NOD_SCE_ATJ_20211116-01

NOTICE OF DEFECT

Energy Safety Inspection Report

Report Name: ATJ_SCE_20211116

Structure ID: 1922670E

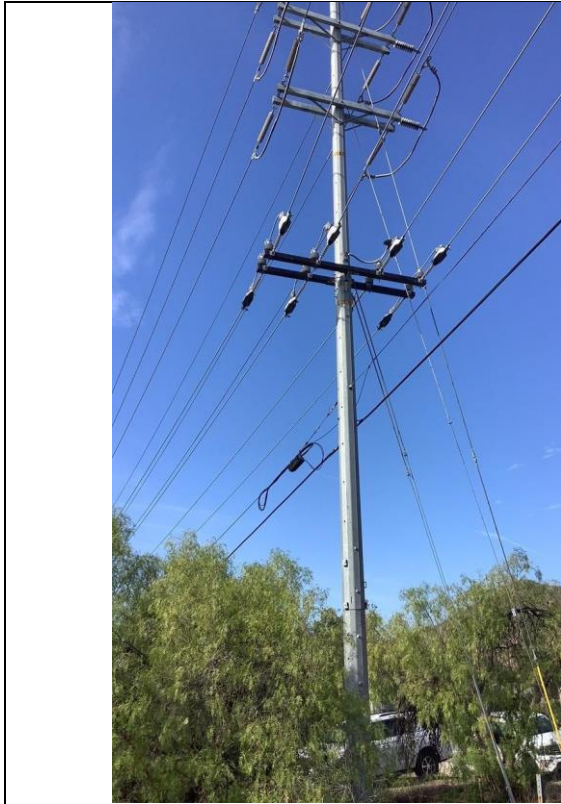
Item2IA1Img1: No vibration dampers installed

Structure ID: 4476903E

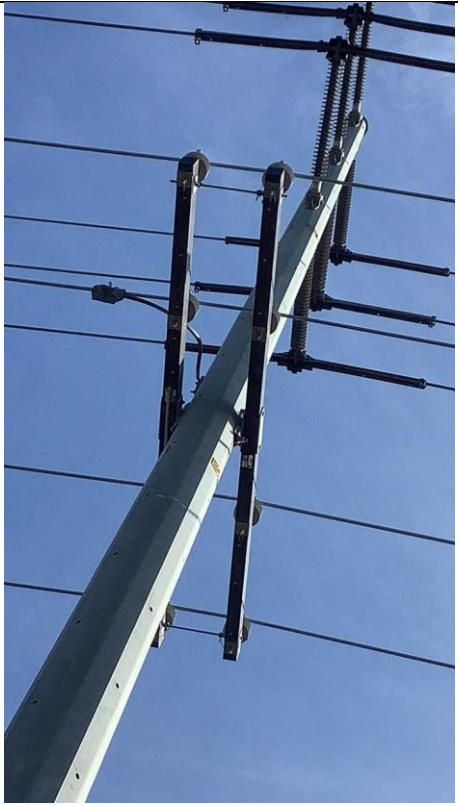
Item10IA1mg1: Vibration dampers not installed
